Pacific Gas and
Electric Company

PG&E Letter DCL-01-115

Docket No. 50-275, OL-DPR-80
Docket No. 50-323, OL-DPR-82
Diablo Canyon Units 1 and 2
License Amendment Request 01-05
Revision to Technical Specification 1.1, "Definitions, Dose Equivalent I-131," and Revised Steam Generator Tube Rupture and Main Steam Line Break Analyses

REVISED TECHNICAL SPECIFICATION 1.1 THYROID DOSE CONVERSION FACTORS AND REVISED STEAM GENERATOR TUBE RUPTURE AND MAIN STEAM LINE BREAK ANALYSES

Figure 15.4.3-5 Ruptured Loop Hot and Cold Leg RCS Temperature

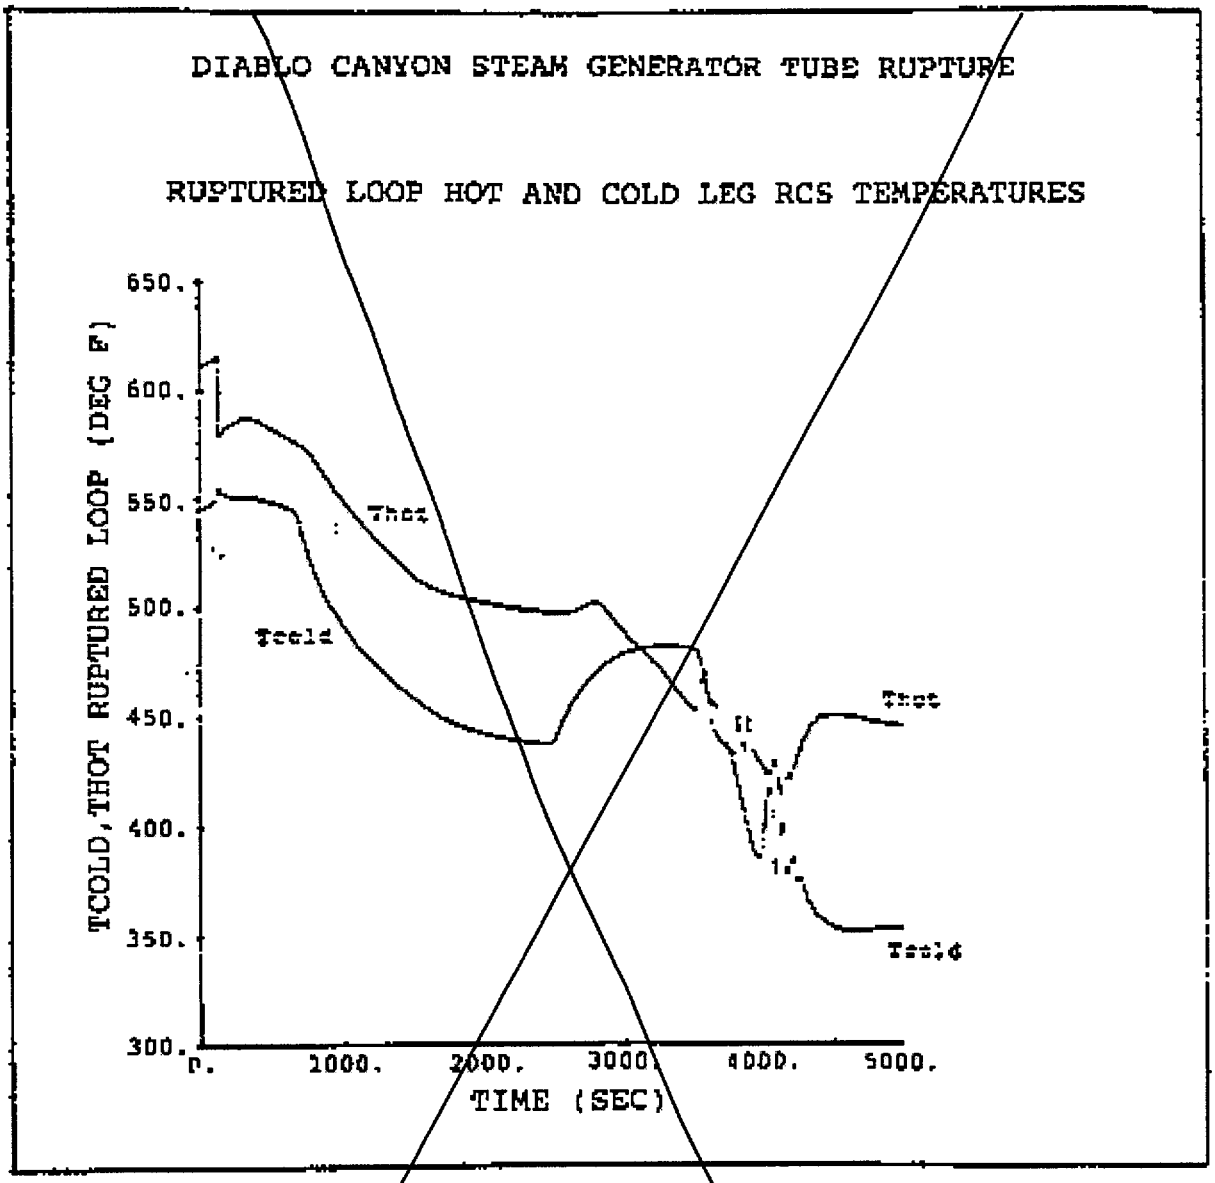
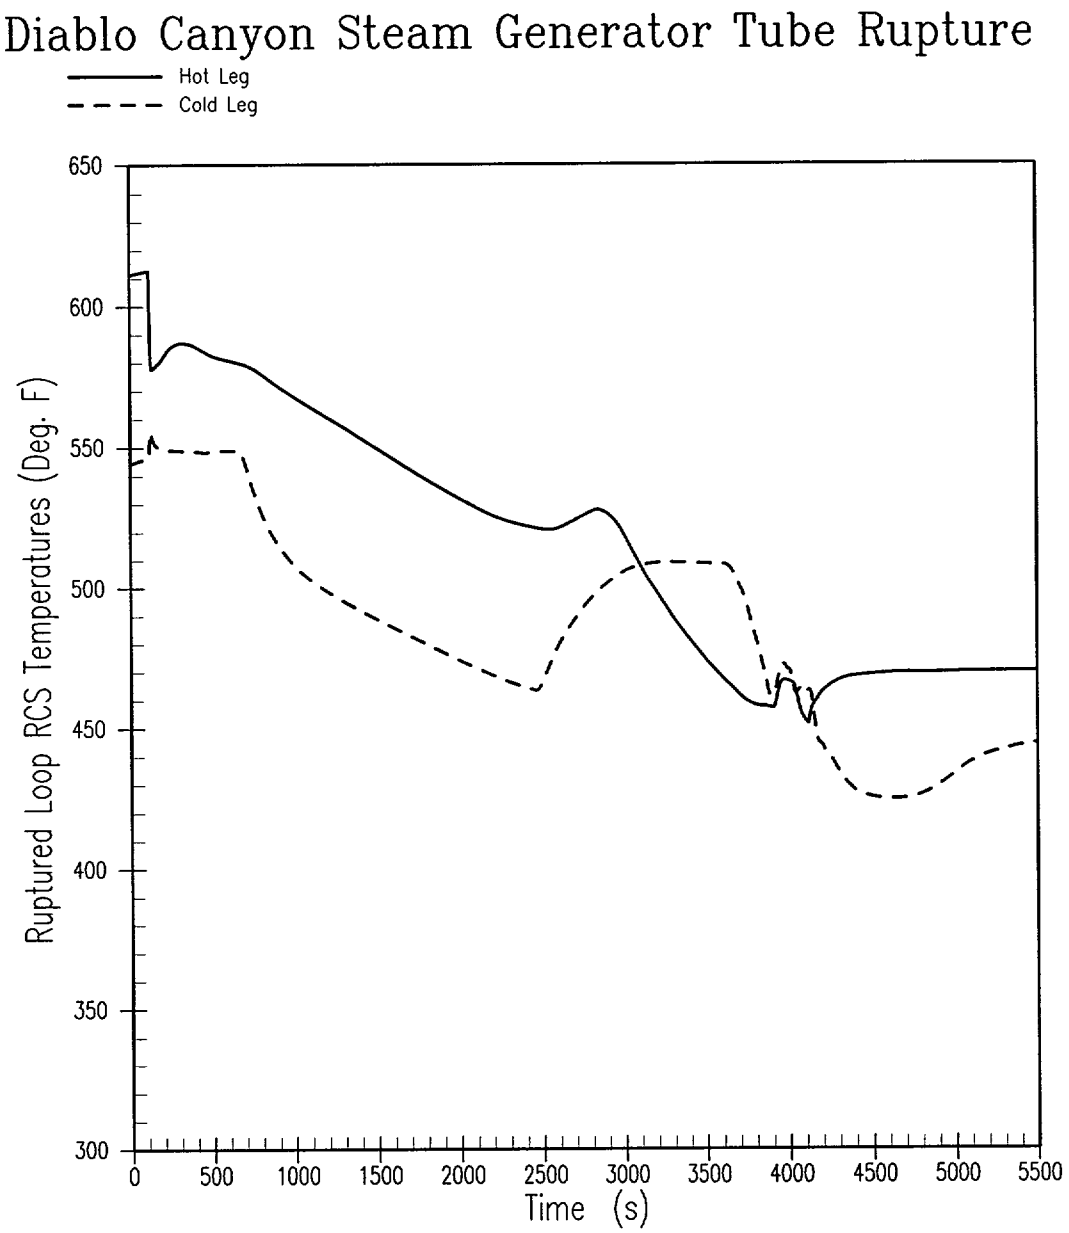
Replace with Figure 15.4.3-5

Figure 15.4-103 Ruptured Loop Hot and Cold Leg RCS Temperatures

Figure 15.4.3-6 Primary to Secondary Break Flow Rate

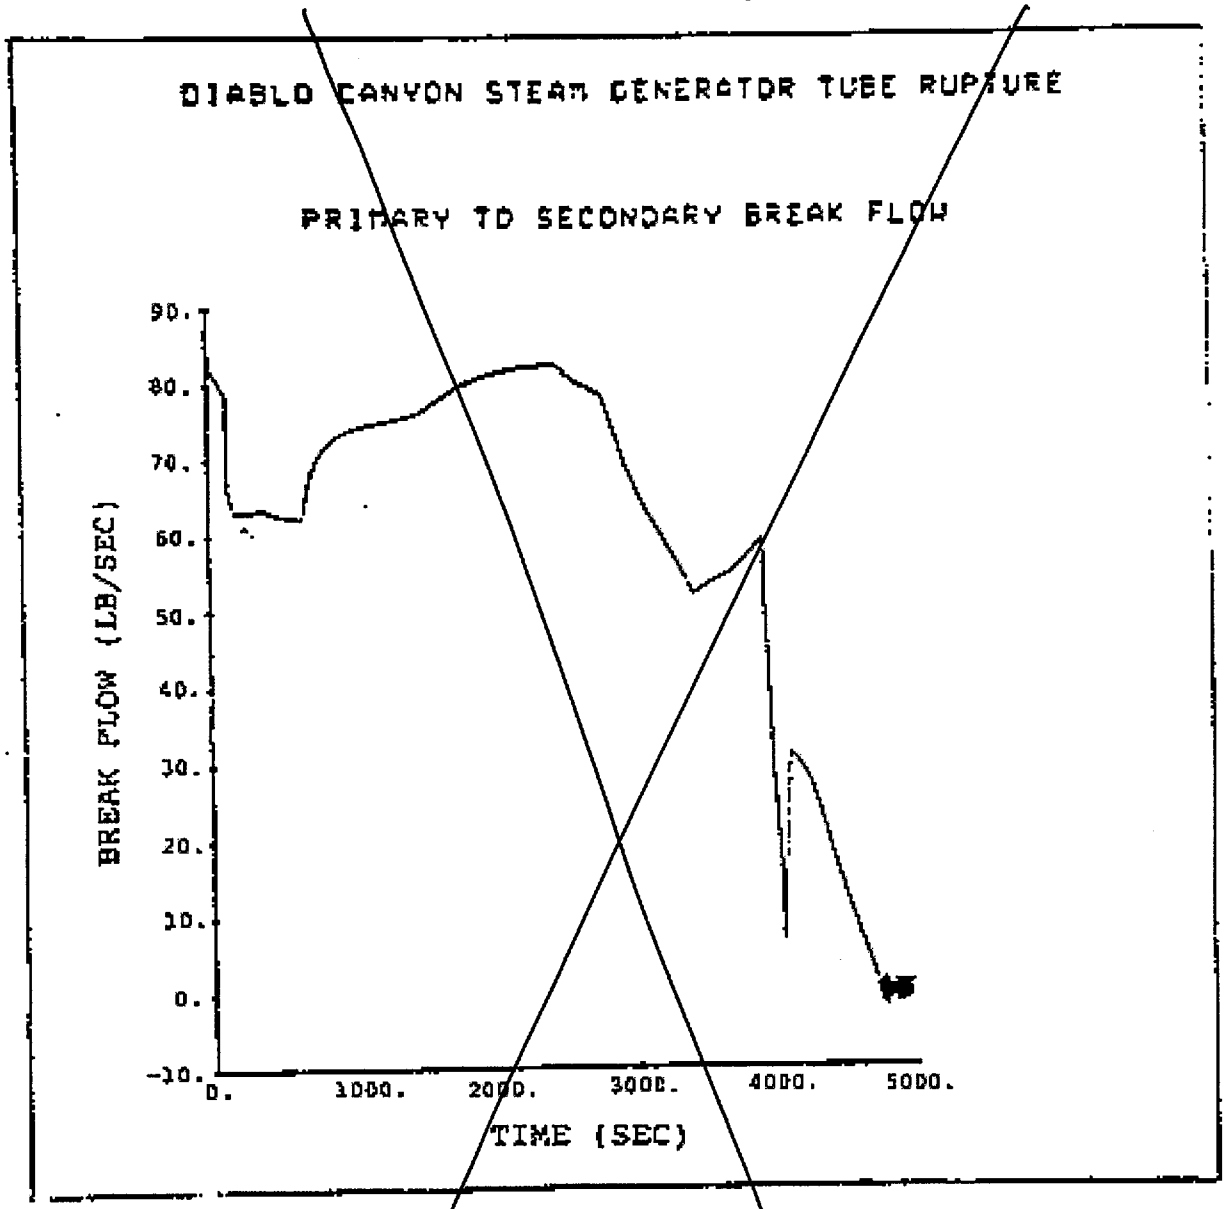
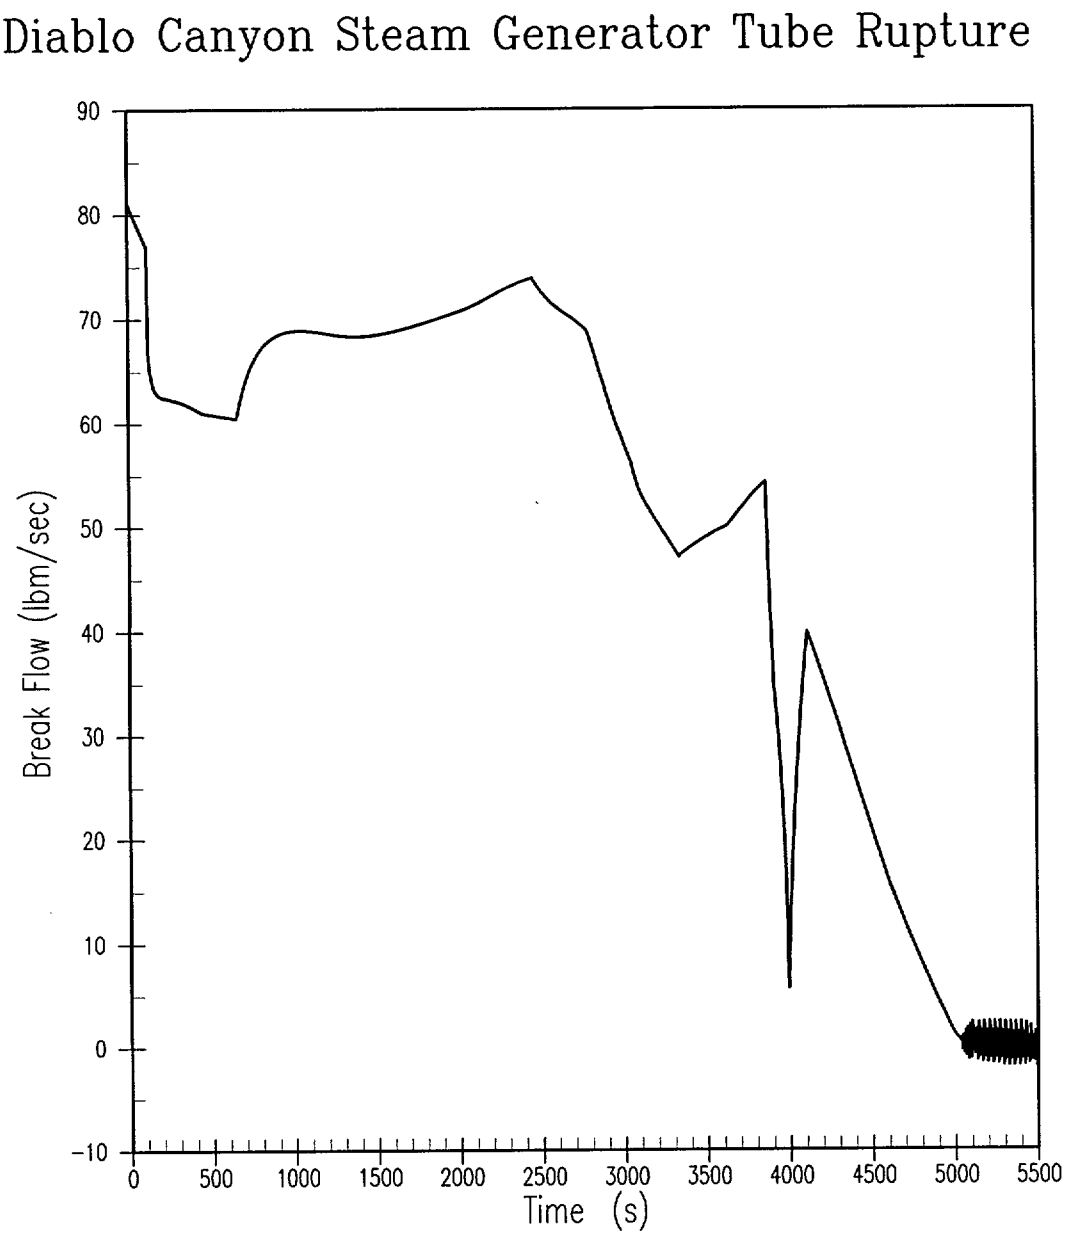
Replace with Figure 15.4.3-6

Figure 15.4-105 Primary to Secondary Break Flow Rate

Figure 15.4.3-7 Ruptured SG Water Volume

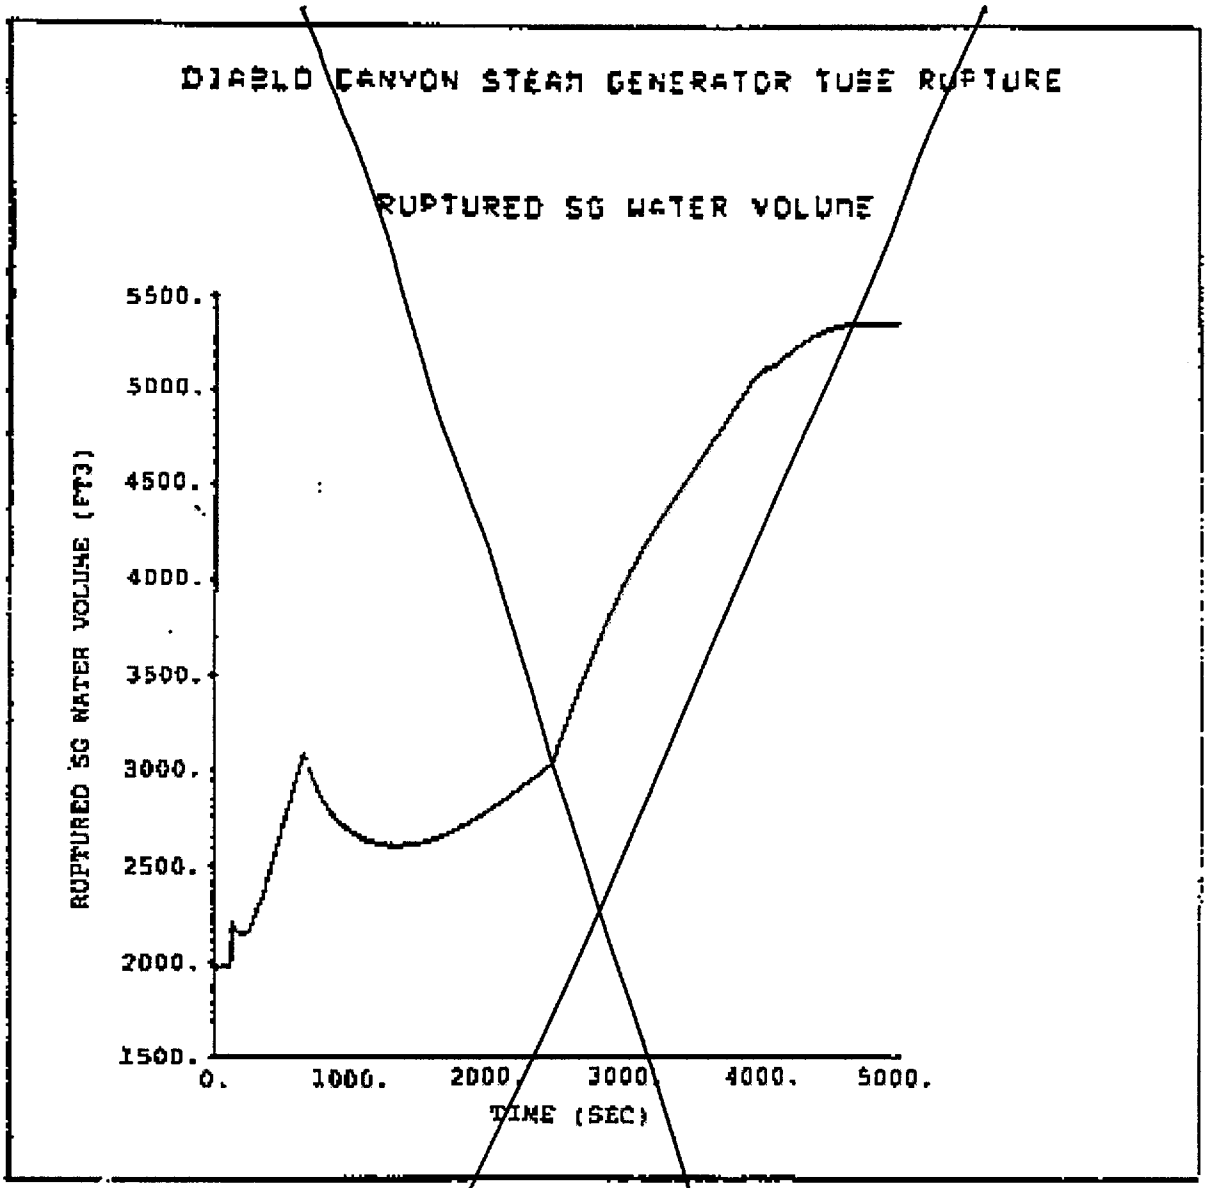
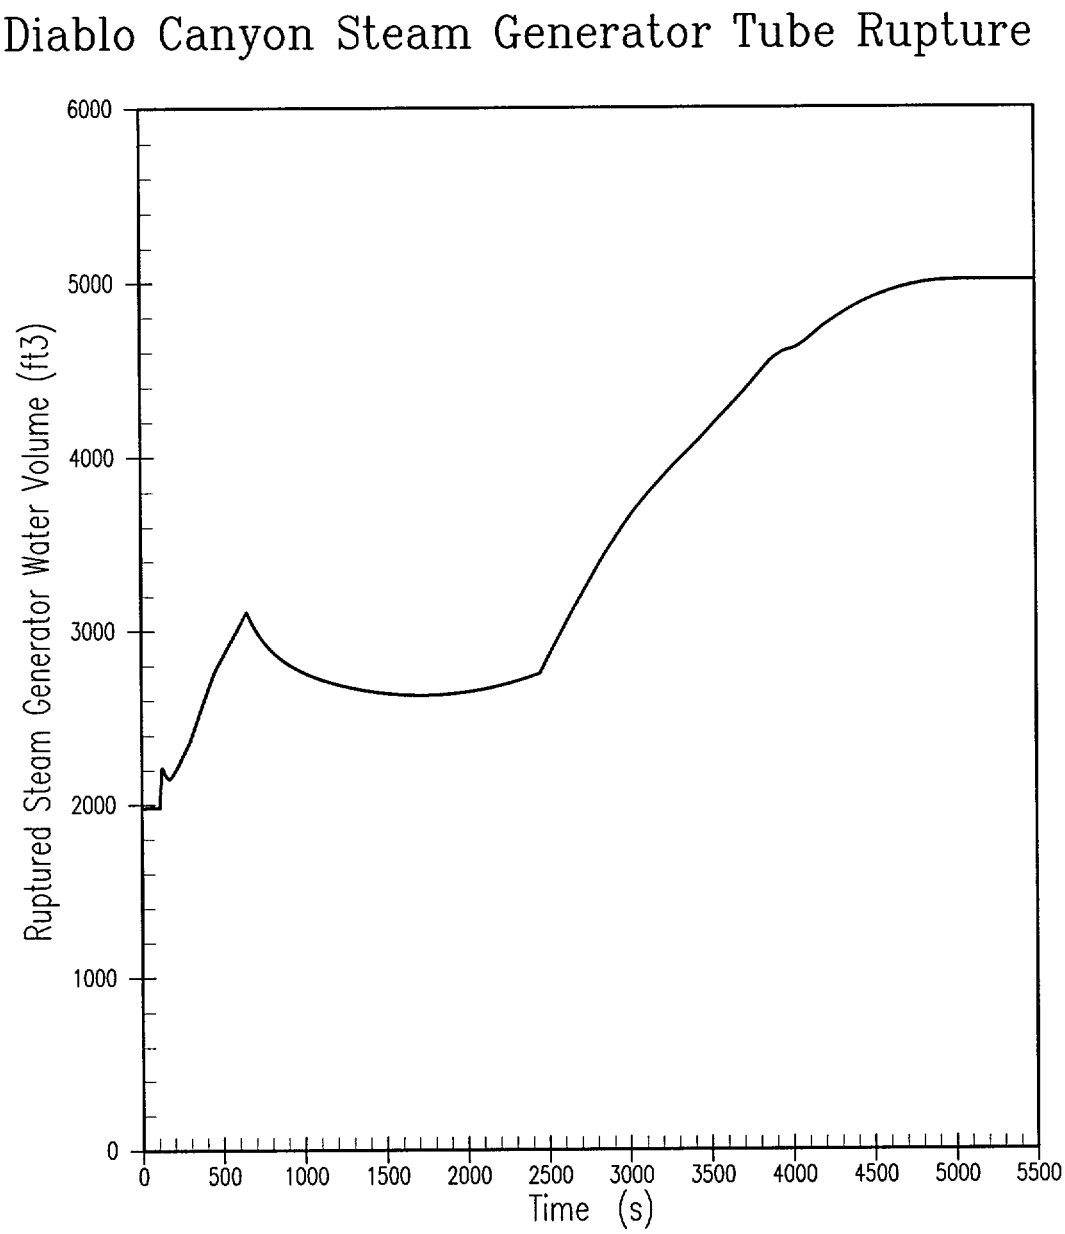
Replace with Figure 15.4.3-7

Figure 15.4-106 Ruptured SG Water Volume

Figure 15.4.3-8 Ruptured SG Water Mass

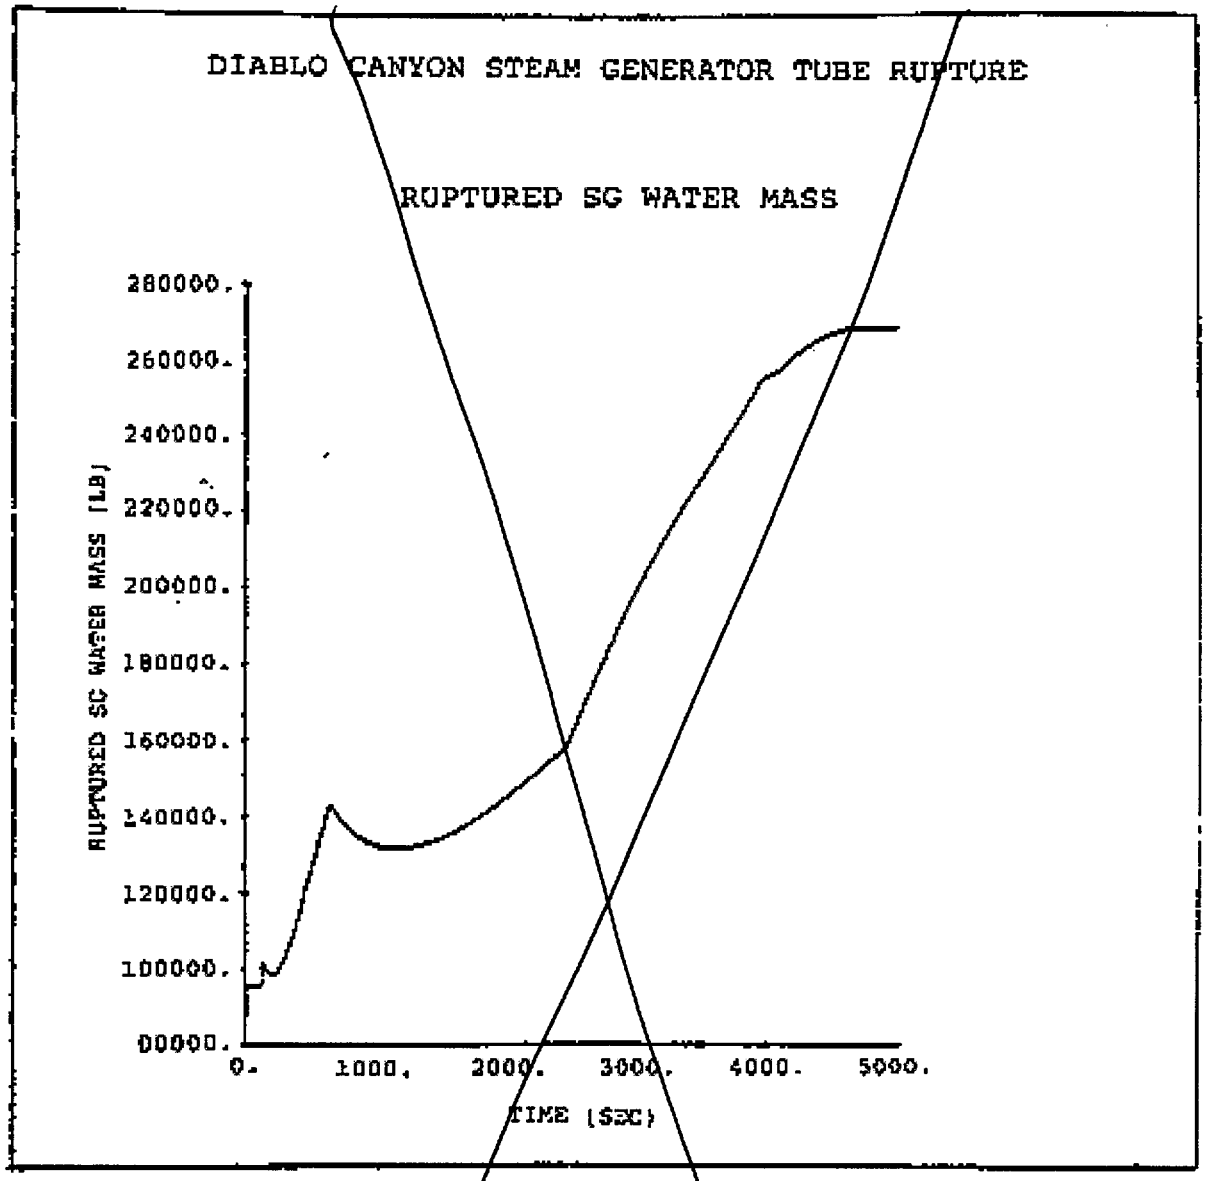
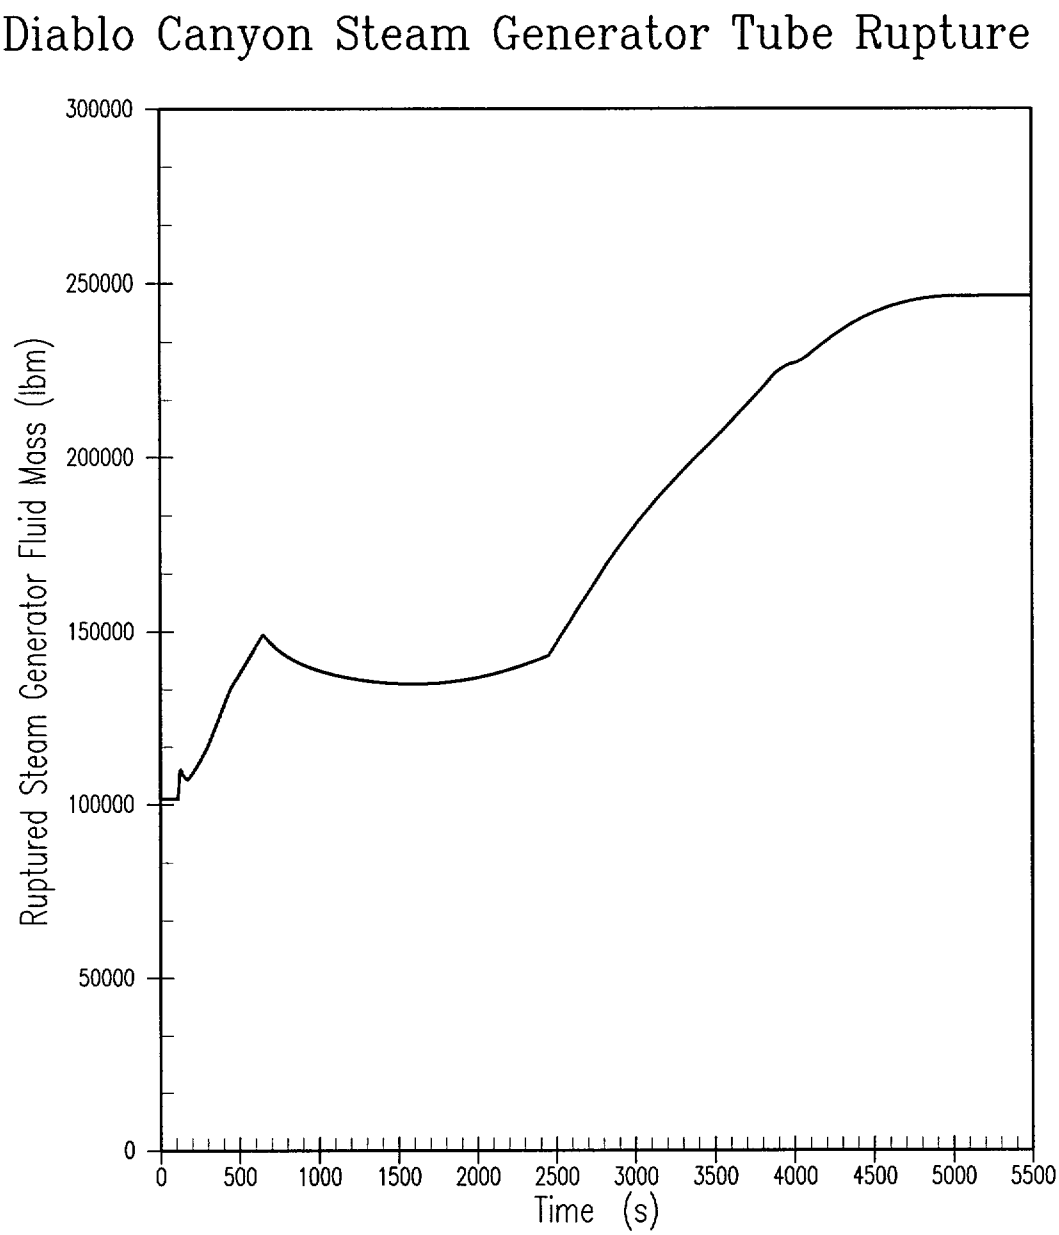
Replace with Figure 15.4.3-8

Figure 15.4-107 Ruptured SG Water Mass
